ADDENDUM NUMBER:	**Addendum - ONE**
PROJECT TITLE:	**RE-BIDDING of:**
	Exterior Façade Restoration
	Milwaukee Public Museum **Site Number: 275** **Building Number: 60** **800 West Wells Street** **Milwaukee, Wisconsin 53233-1478**
PROJECT NUMBER:	**O114-11443**
DATE OF ADDENDUM:	**April 09, 2013**

This Addendum to the Contract Documents is issued to modify, explain or correct the original Documents, Dated January 19,2013, and is hereby made part of the Contract Documents. Acknowledge receipt of this addendum in the space provided on the Bid Form, or bid maybe rejected.

5 PANEL SUPPORT @ EXTERIOR WALLS

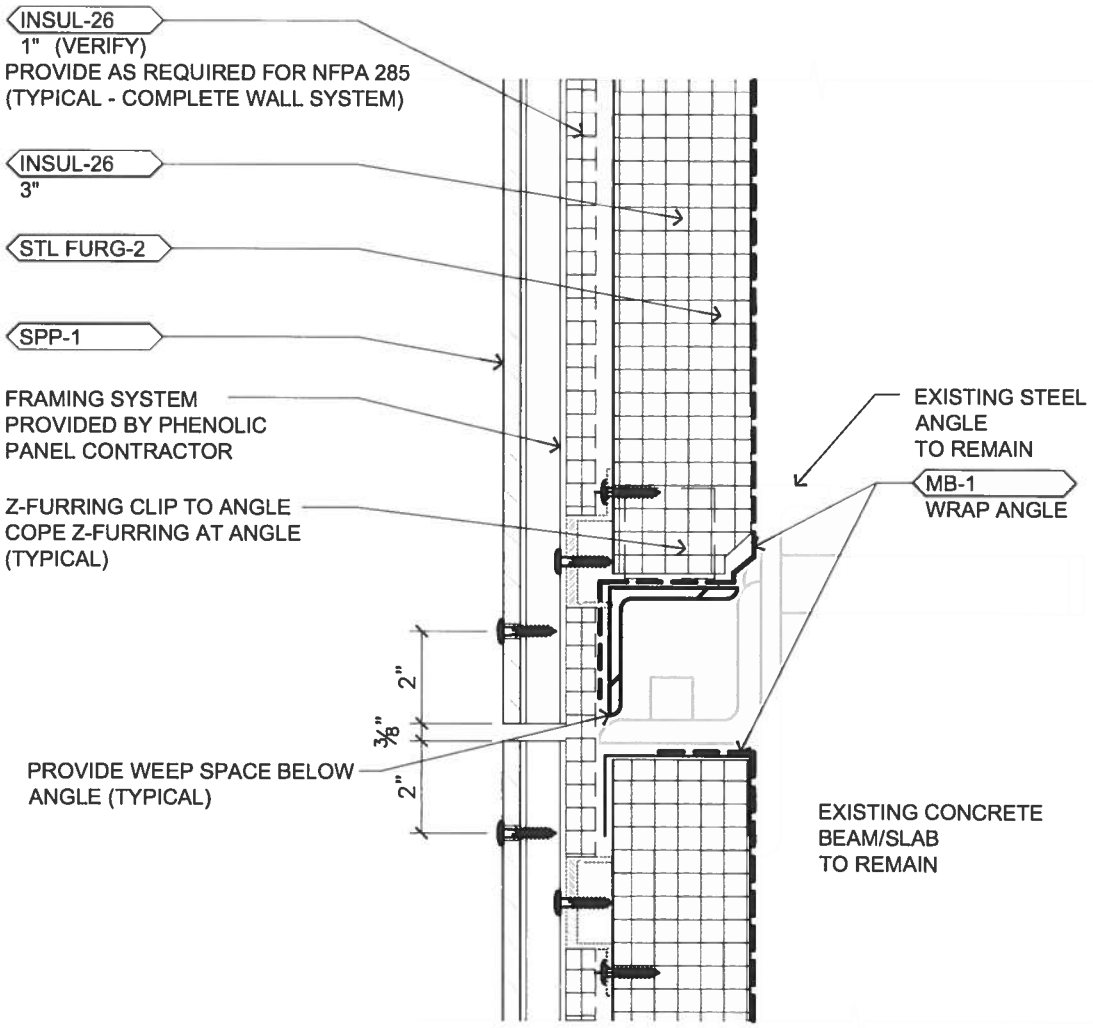
SHEET A5.1
Replace Detail 5 with the attached Detail 5, (see attachments).
